Access Compliance Report

Public Rights-of-Way

(Curb Ramps)

Intersection ID: 12320	Main Street: ALLEN_ST	Cross Street: BELMONT_AV	Location:	N
ADA ID: BC237178AE4D	Ramp Type: BlendTrans1	Initial Pass/Fail: Fail	Overall Compliance: No	Severity Score: 8.75
Codes/Mitigation Info/Possible Solution		Field Measurements/Component Compliance

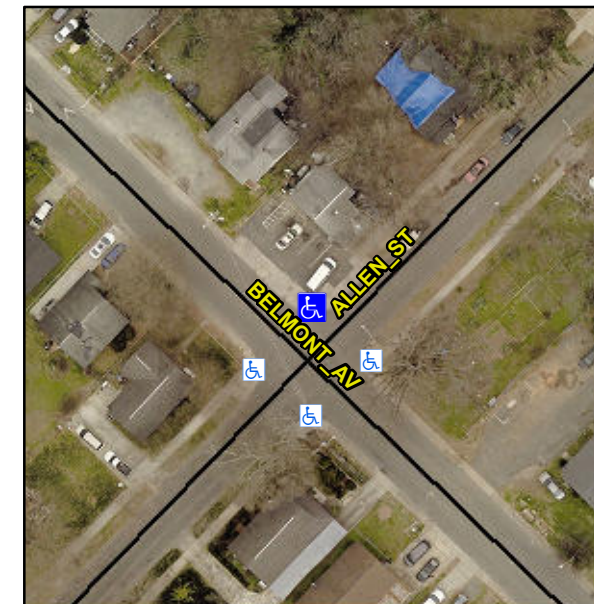
Possible Solutions:

Remove & Replace Curb Ramp With Two New Directional Ramps or Equivalent.

PROW/ADA:

R304.5.1
